ADDENDUM NO. 1

BID NO. 2020-009

BLUEWAY TRAIL IMPROVEMENTS

ADDENDUM NO. 2

Public Works Boat Ramps

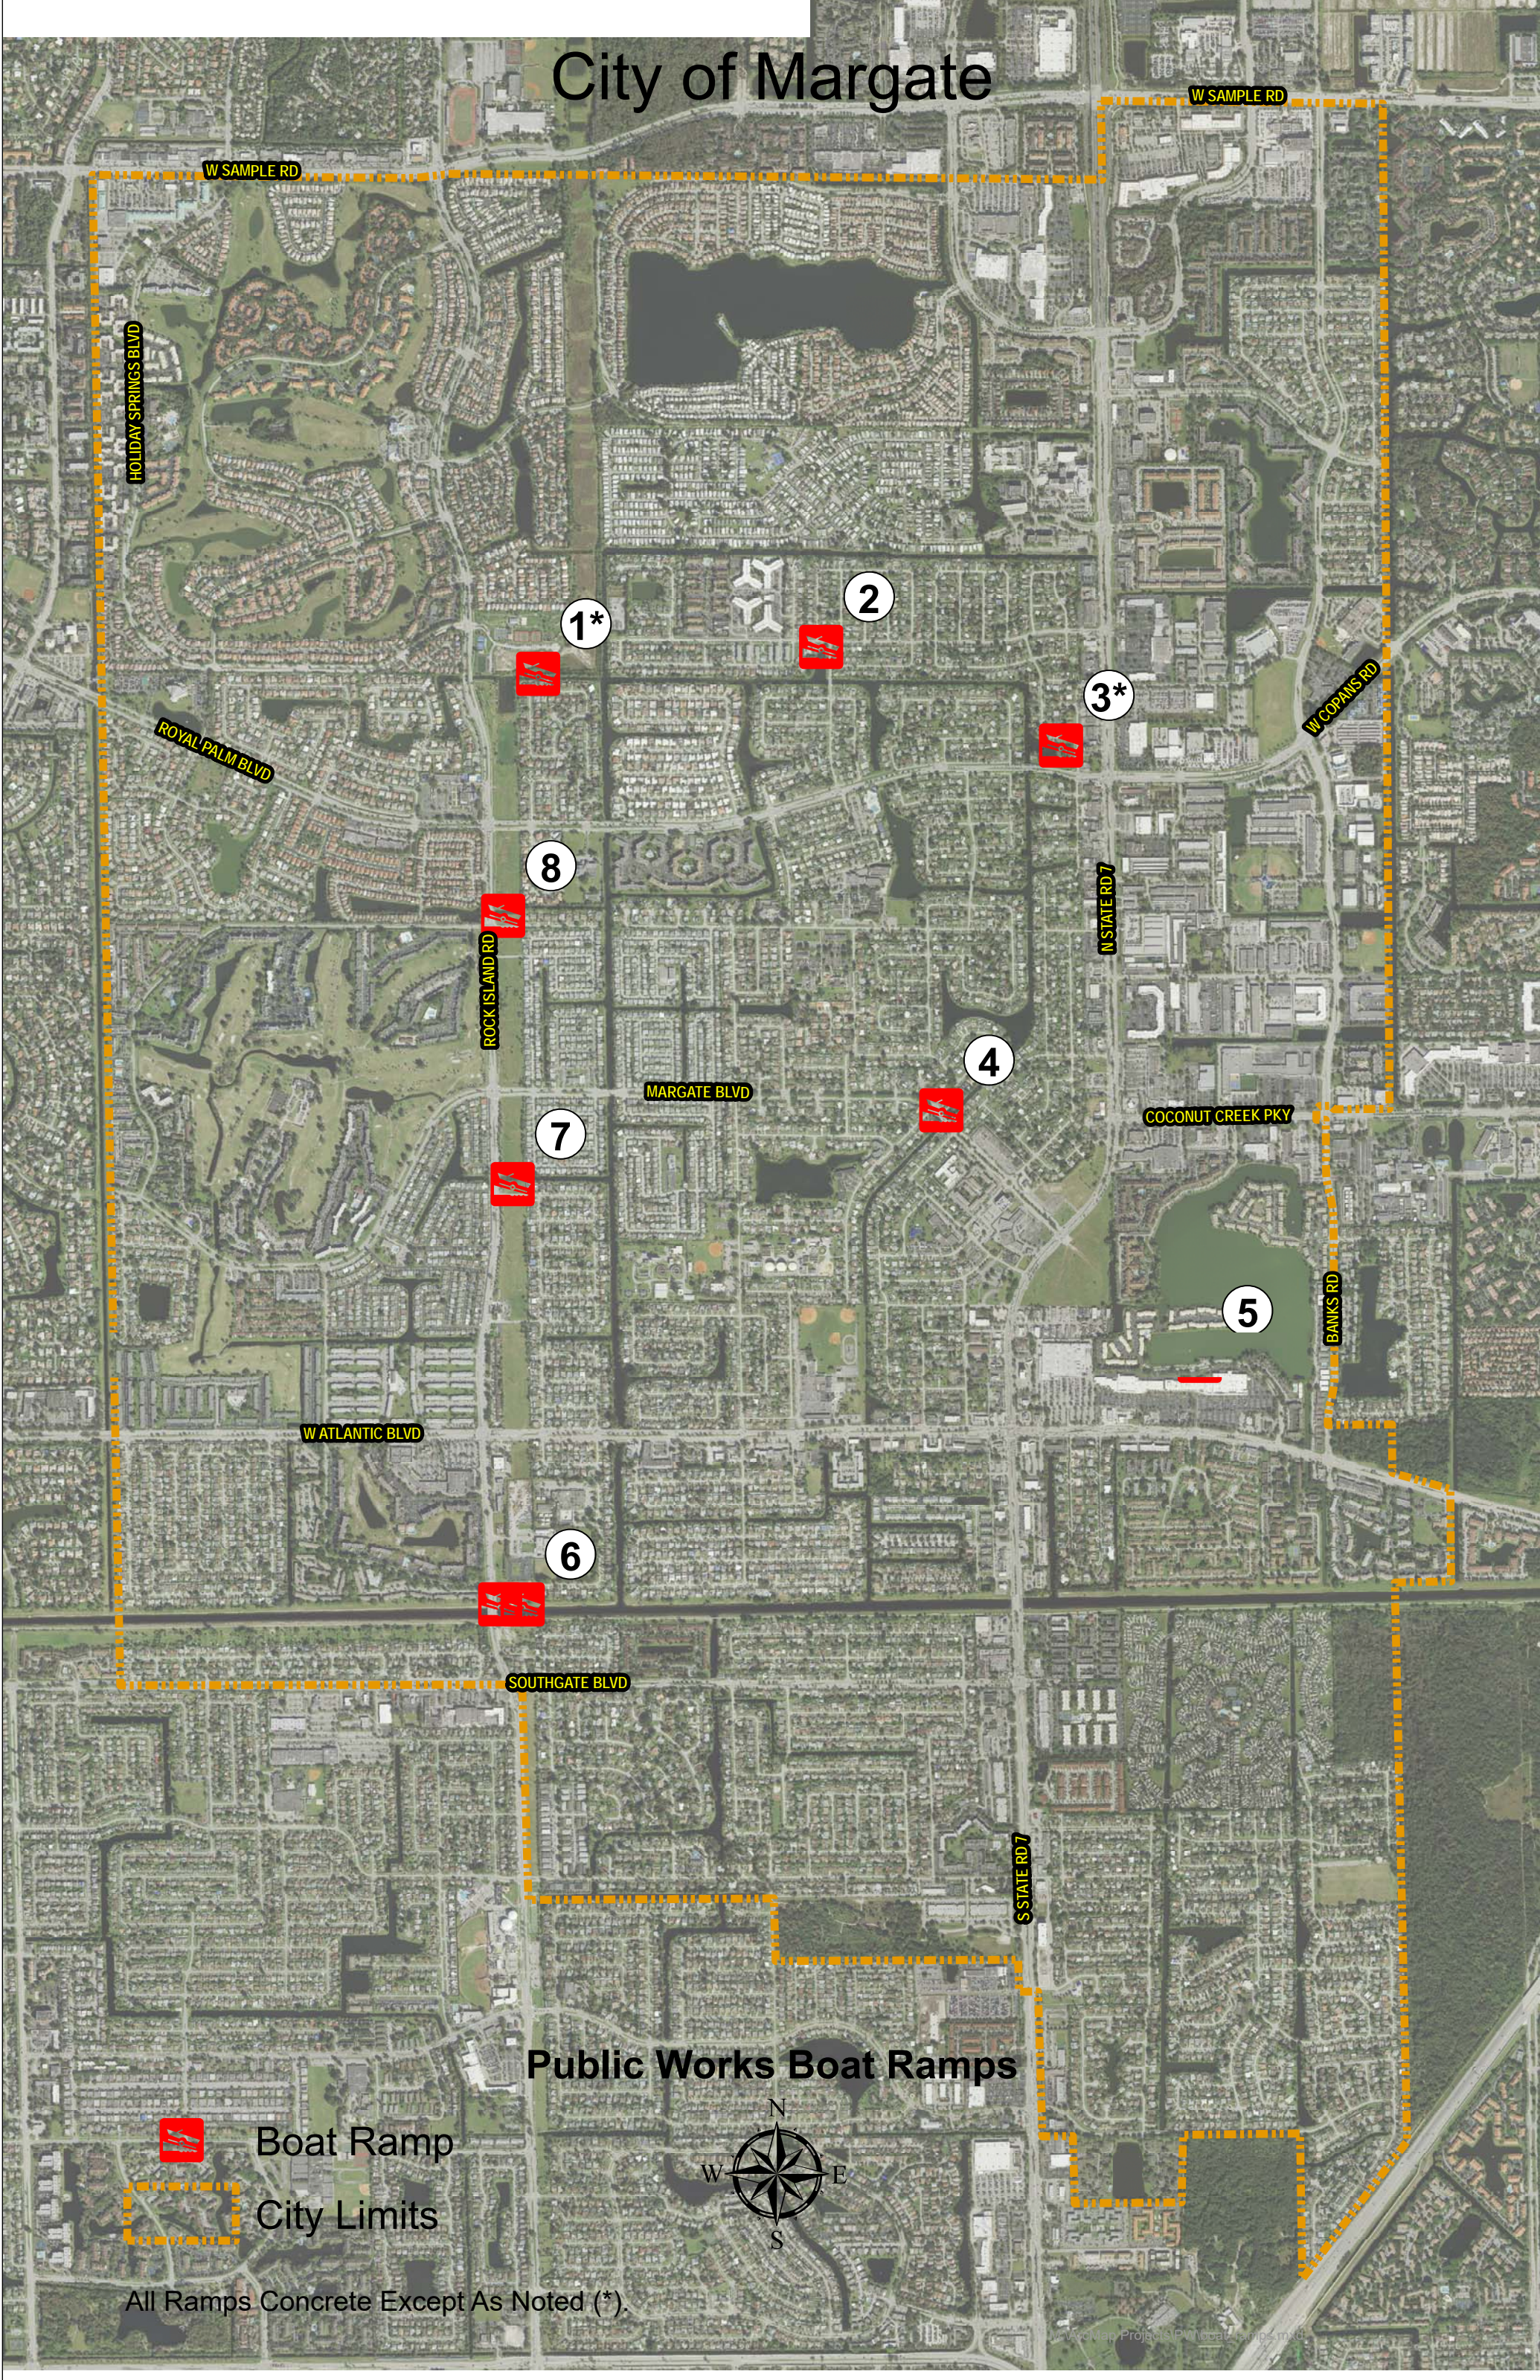
8. How will access be made available to the locations identified for each of the sign installations, for the equipment necessary to drive 10" x 18' pilings at the water's edge or in the water? Landside is mostly residential backyards with fences and structures, and waterway is non-navigable for equipment.

Answer: Contractors will have access to all City boat ramps (upon reasonable notice). Refer to City Boat Ramp Map attached for identification of ramp locations.

Addition: Add City Boat Ramps Map page to Technical Specifications following the above addition of the Crossed Oars page.
